**Portland General Electric Company**  
*Trojan ISFSI*  
71760 Columbia River Hwy  
Rainier OR 97048

**Transmittal of Revision 7 to the Trojan Independent Spent Fuel  
Storage Installation (ISFSI) Emergency Plan, PGE-1075**

**Changes Incorporated into Revision 7 to the Trojan ISFSI Emergency Plan, PGE-1075**

**Trojan Independent Spent Fuel Storage Installation (ISFSI) Emergency Plan, PGE-1075**

**FIGURE 1-3**  
**ISFSI CONTROLLED AREA BOUNDARY**

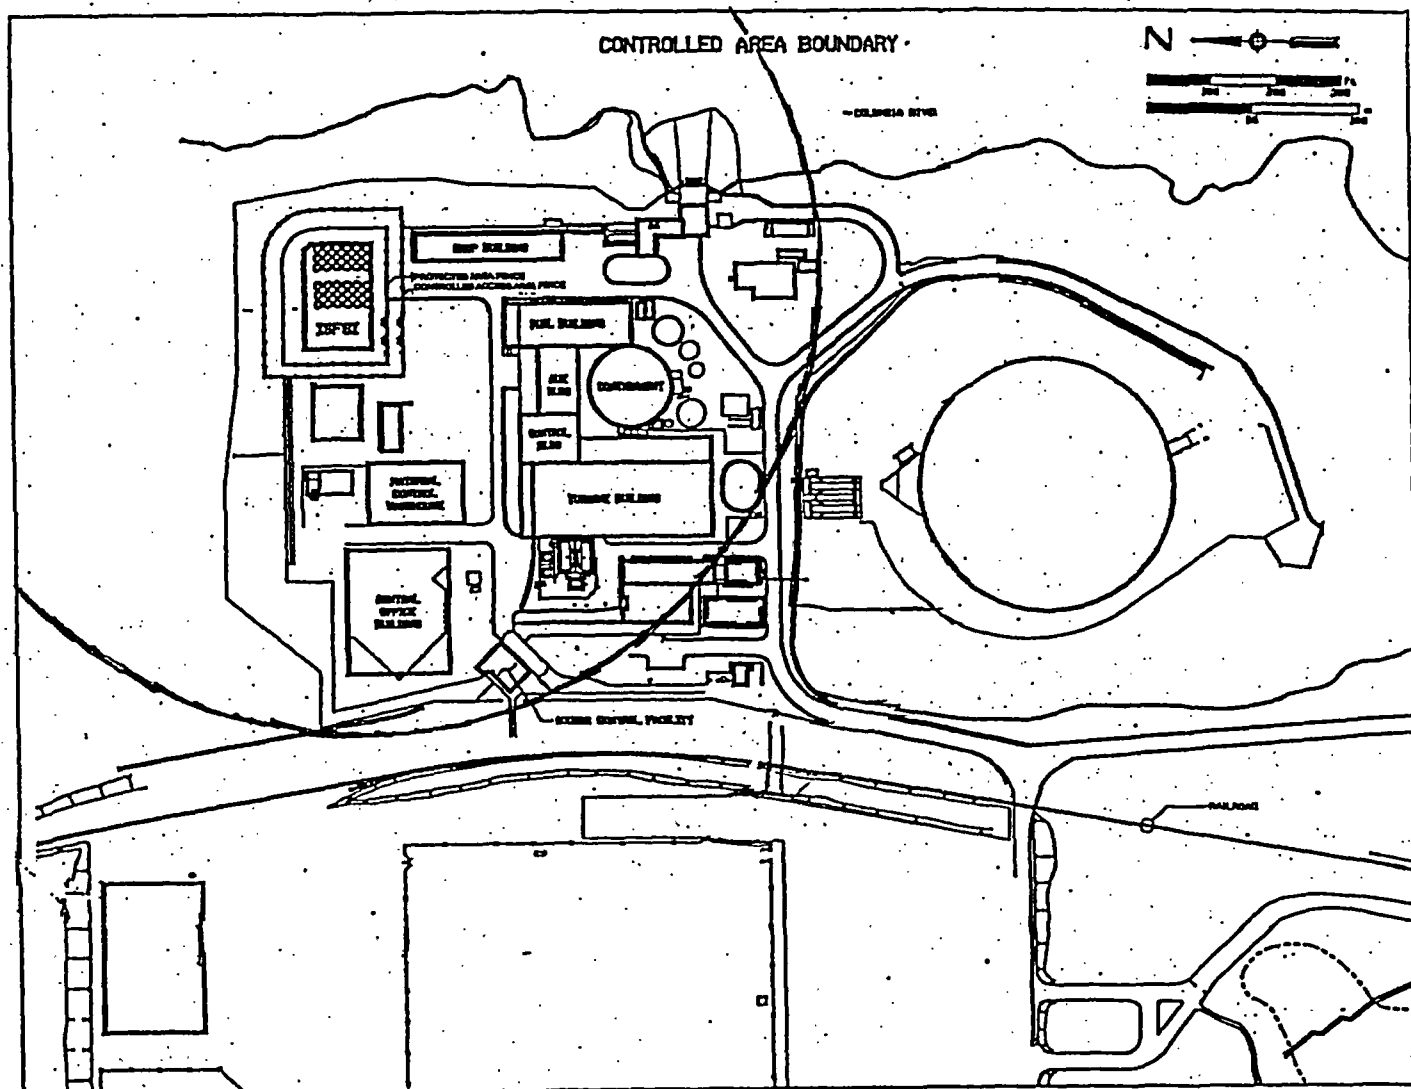
1. Section 1.2 - Changed 300 meters to 200 meters, and deleted the reference to Portland and Western Railroad right of way, as the railroad track is no longer within the CAB.
2. Section 2.2 - Changed position title "Shift Manager" to "ISFSI Manager".
3. Section 4.4 - Deleted the references to Portland & Western Railroad right of way and rail traffic control.
4. Appendix – Agreements. Deleted agreement with Portland & Western Railroad, Inc.
5. Figure 1-2, "Location of the Trojan ISFSI at the PGE Site," changed to show 200 meter CAB line.
6. Figure 1-3, "ISFSI Controlled Area Boundary," changed to show 200 meter boundary line.

1. Deleted references to the cooling tower in Section 1.2, Section 1.4.3, and Figure 1-3, "ISFSI Controlled Area Boundary."
2. Deleted entire Section 1.4.3.5, Cooling Tower Collapse.
3. Deleted entire Section 2.1.2.10, Cooling Tower Collapse.
